January 15, 2026

CONTRACT NO. 1797

OHIO RIVER TUNNEL

ADDENDUM No. 12

ALLEGHENY COUNTY SANITARY AUTHORITY (ALCOSAN)
OHIO RIVER TUNNEL (ORT)
O06A-ST-806
CCT-O06A-RG PLANS
SHEET 1 OF 2

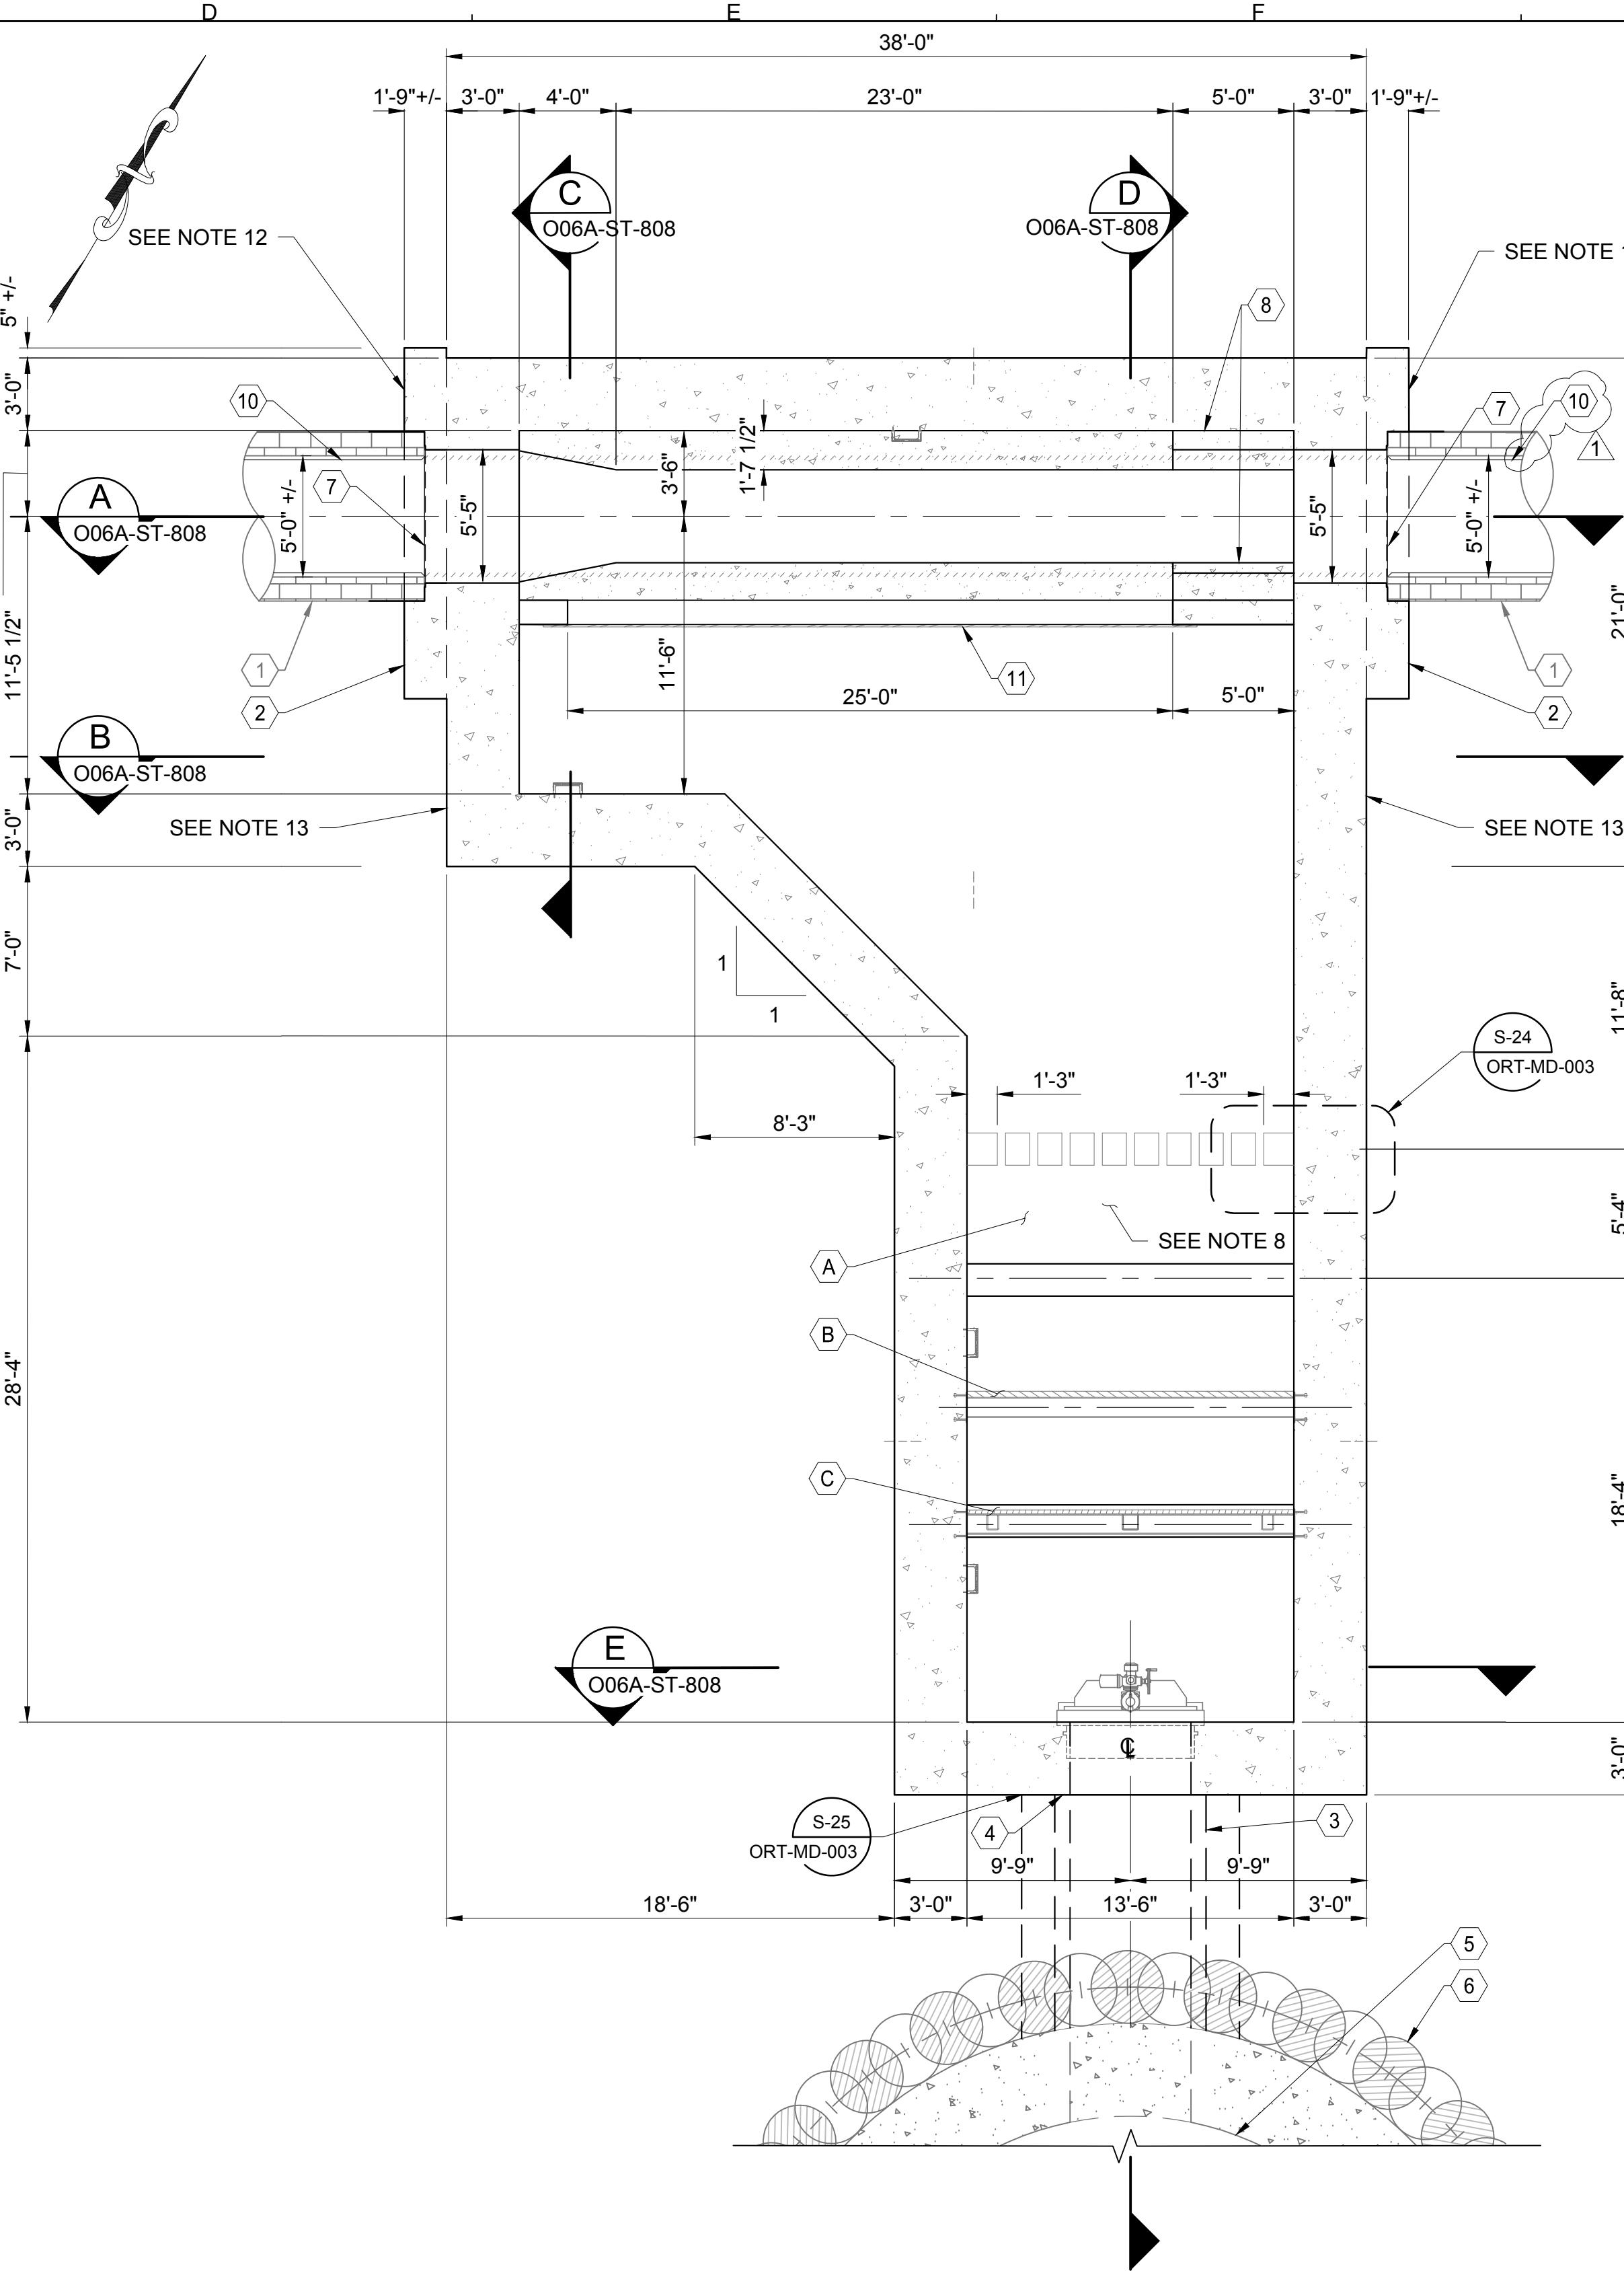
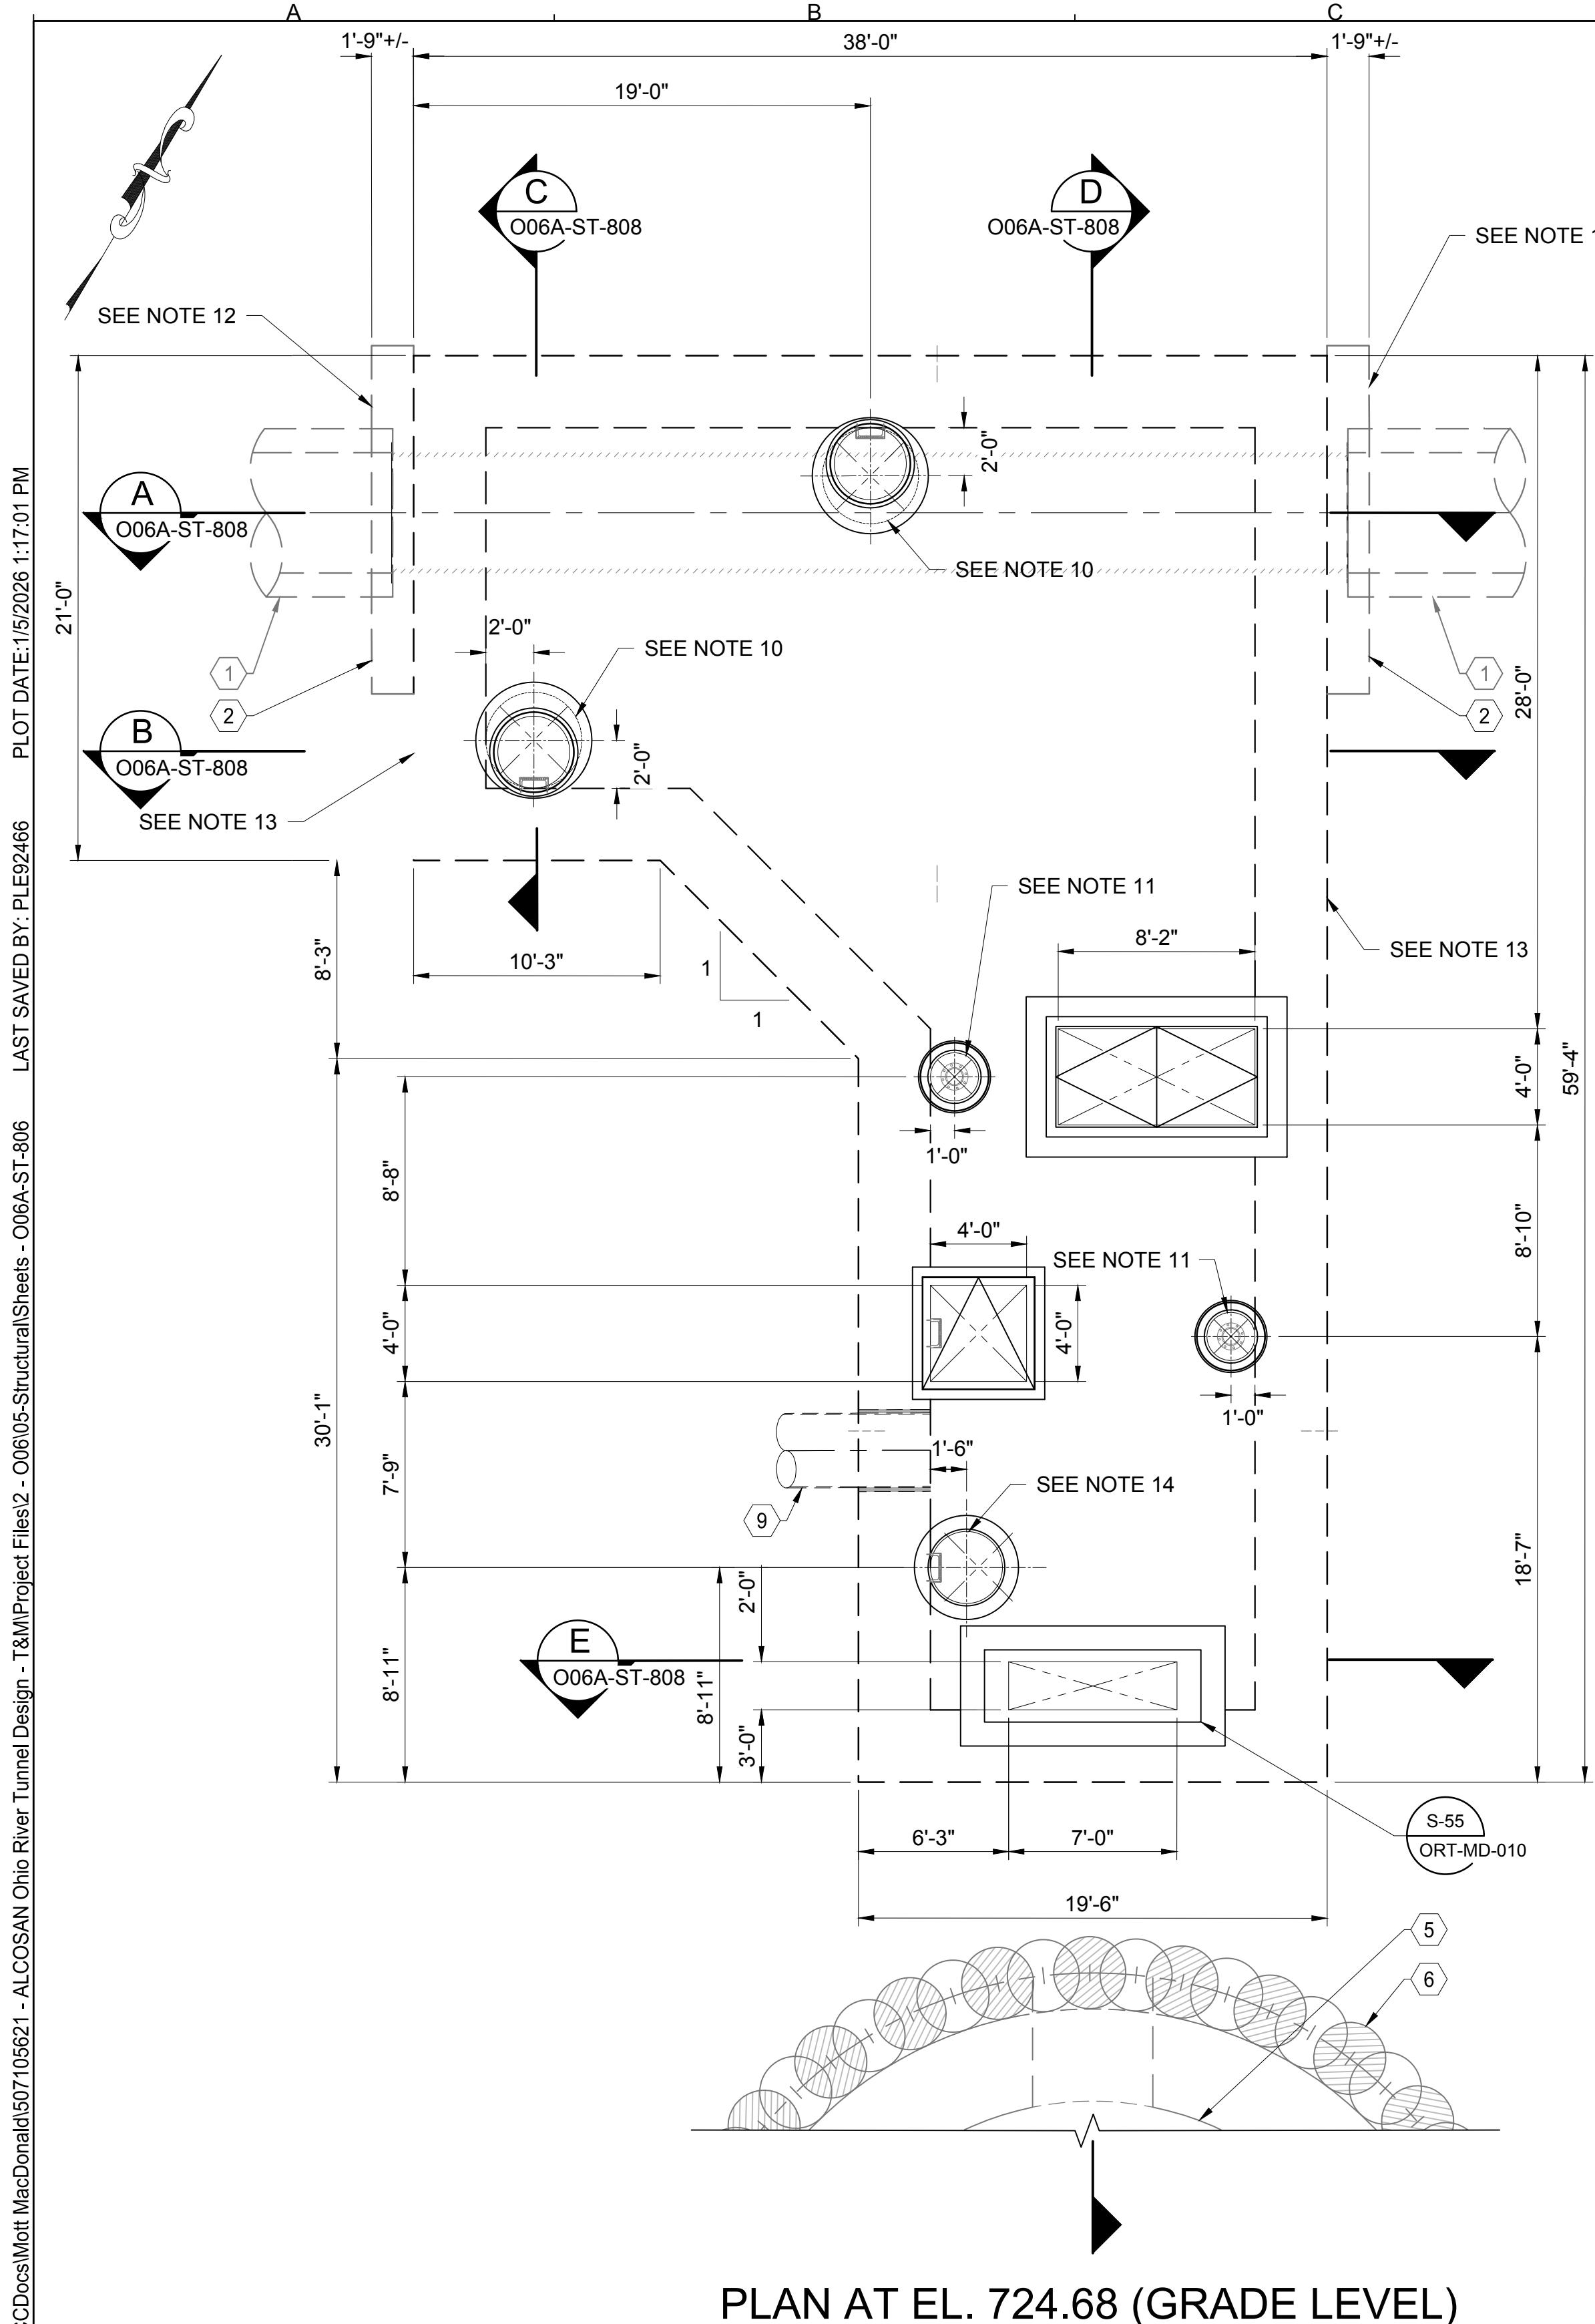
Q13 *Drawing O06A-ST-806 Key Notes 10 calls for CIPP lining. Other drawings call for 20 ft of shotcrete. Is this drawing requiring glass fiber reinforced, flexible polyester felt or fiberglass fiber tube impregnated with corrosion resistant polyester thermosetting resin on top of shotcrete. If so, what is the total length of CIPP required?*

- d. DELETE O06A-ST-806 (Sheet 629 of 770) and ADD revised O06A-ST-806 (Sheet 629 of 770), which is Attachment C of this Addendum.
7. APPENDIX C - GEOTECHNICAL BASELINE REPORT, Section 7 Ground Characterization, 7.9.4 SINTEF and Miller Number has been REVISED.

A13 **CIPP has been revised to shotcrete (or gunite). Note that full description of shotcrete application, including thickness and extent (across the entire connection zone) in all existing sewers are given in the respective SOE series of drawings per site.**
See Section B, Item 6 and Attachment C of this Addendum for CHANGES TO CONTRACT DOCUMENTS including Contract Drawings O27-ST-122, A48-ST-306, A58-ST-424, and O06A-ST-806.
